Project: 1B D001FL-Sage FC Sales Center
 8152 Fiddler's Creek Parkway
 Naples, Florida 34114
 P: 239-307-8826

RFI #9: Design Center Ceiling

GROUND FLOOR - REFLECTED CEILING PLAN

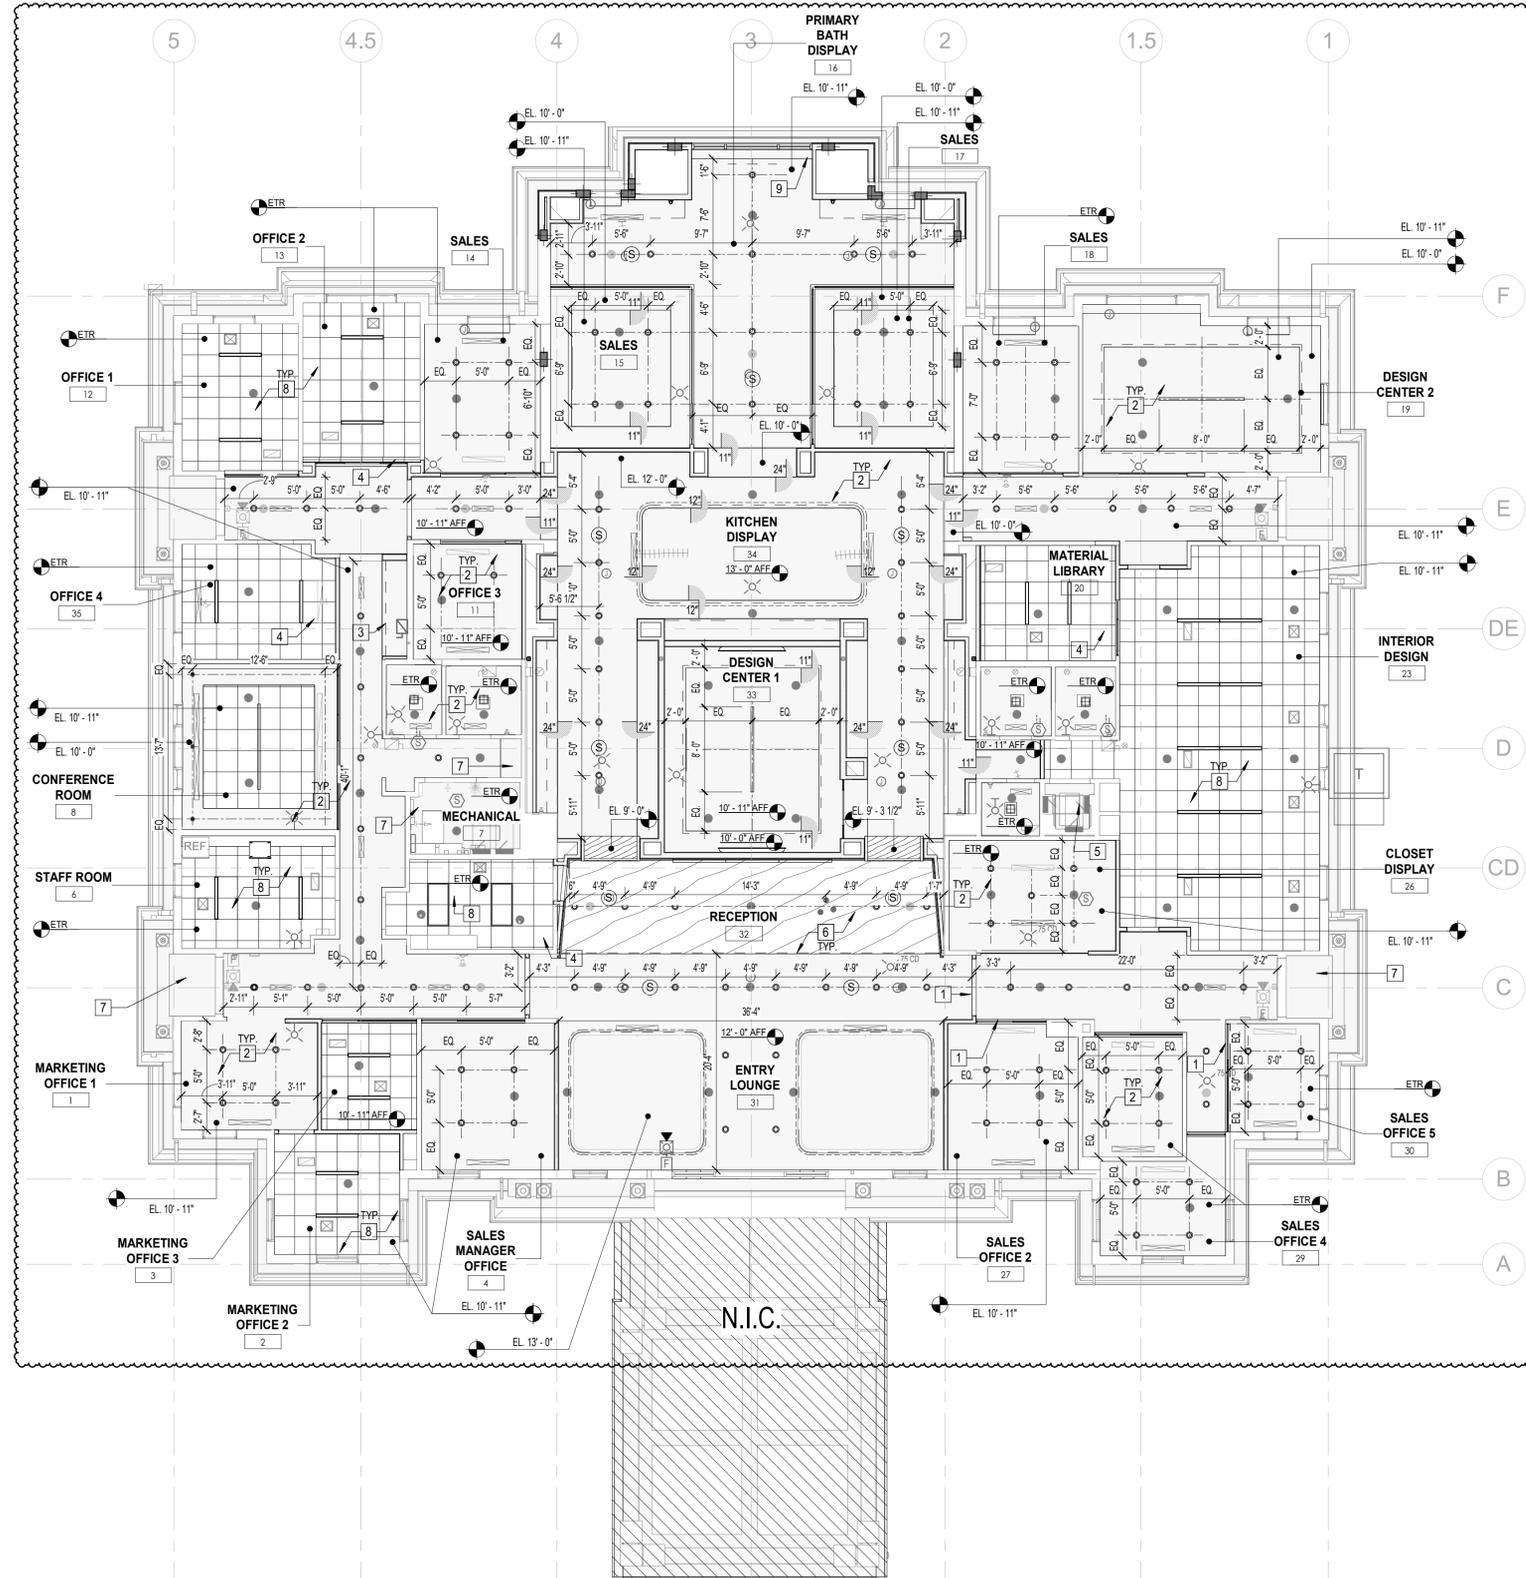
On A-1.00-4 the Design Center Ceiling show what looks to be a light cove. However there are now details showing if it is a simple Coffered ceiling or if there is to be a Light cove.

Please confirm either way
